MAC221510-02LR01

Response to Request for Additional Information
Proposed Primary School Development
125 The Southern Parkway, Forster, NSW

This letter provides a response to a Request For Additional Information from Midcoast Council (MC) pertaining to the Noise Assessment (ref: MAC221510-01RP1D1, March 2022) (NA) prepared by Muller Acoustic Consulting Pty Ltd (MAC) for the Proposed Primary School Development (the 'project') to be located at The Southern Parkway, Forster, NSW. The correspondence from MC and the MAC responses are outlined below.

Figure 1 below provide a visual synopsis of the operational noise model.

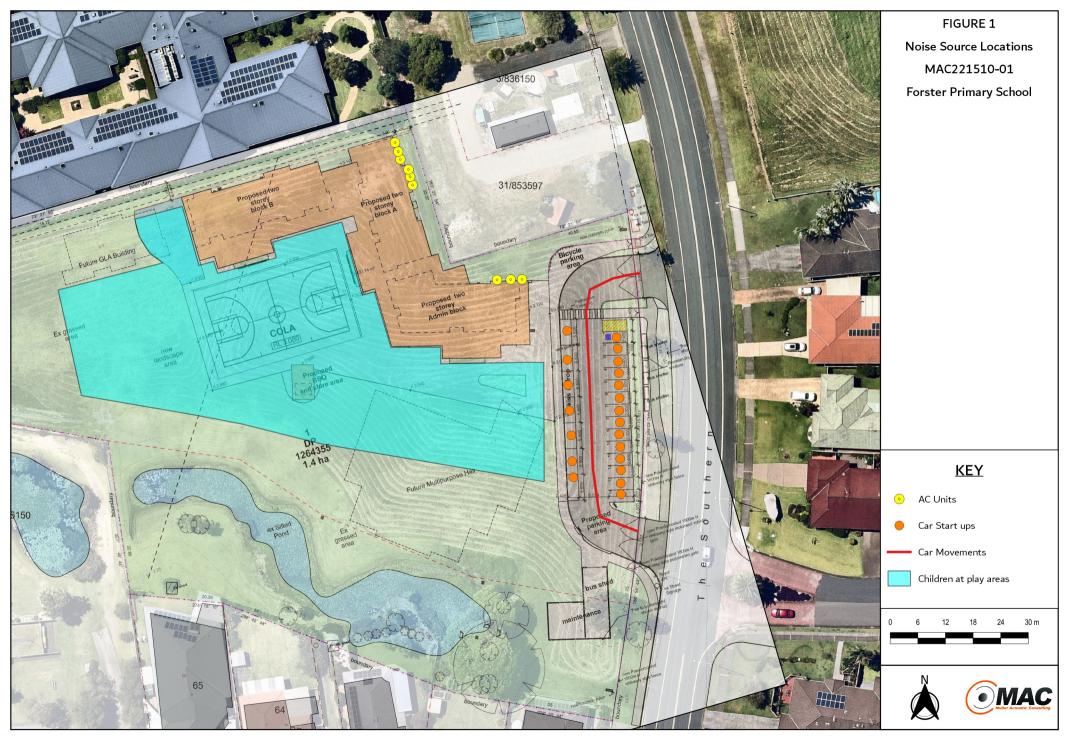
Comment #2 – Location of noise sources and distance to sensitive receivers used to model noise predictions;

Response #2 – Section 6.2 of the NA report outlines the assumed location of the mechanical plant for the development. The NA states that AC units are assumed to be located on the north east of the administration and Block A buildings. This locates the units away from student play areas and the nearest residential receiver located to the north of the project site.

Parent/teacher car start up and drive off and cars travelling through the drop off area are located within the proposed car park. As there are numerous sources and receiver combinations included in the predictive modelling it is not practical to outline the offset distance from each source to each receiver.
